SUNDRY NOTICES AND REPORTS ON WELLS
Do not use this form for proposals to drill or to re-enter an abandoned well. Use Form 3160-3 (APD) for such proposals.

OXY USA Inc.

Sundance B Federal #1

30-015-27225

OXY USA Inc. - Proposed
Sundance 8 Federal #1
API No. 30-015-27228

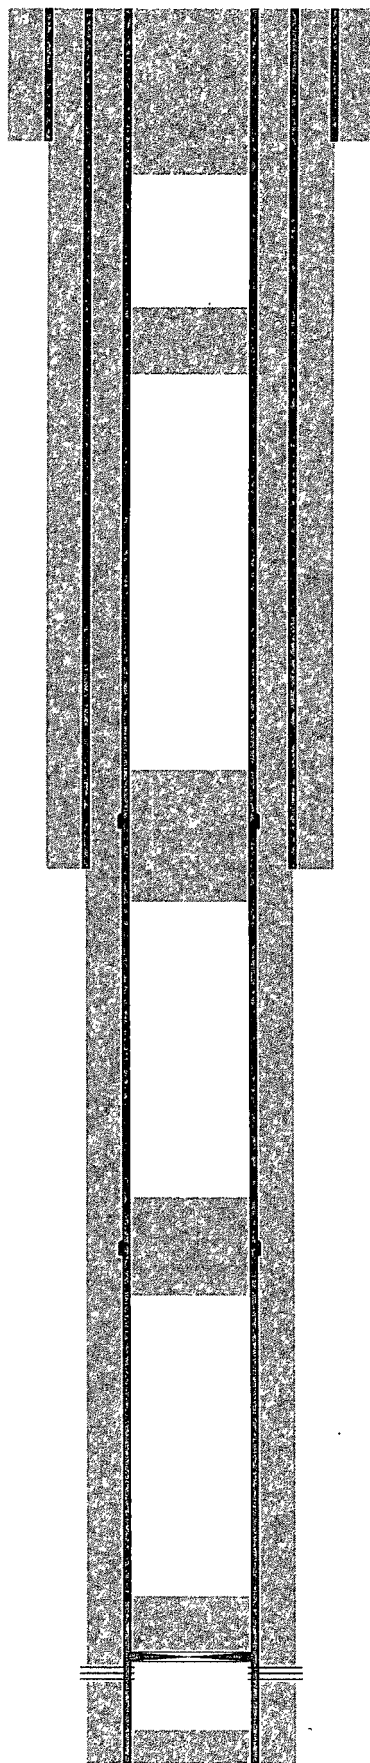
880-780 (T/salt) WOC Tag
Suggest combining w/ #5 plugRECLAMATION PROCEDURE
ATTACHED14. I hereby certify that the foregoing is true and correct
Name (Printed/Typed)
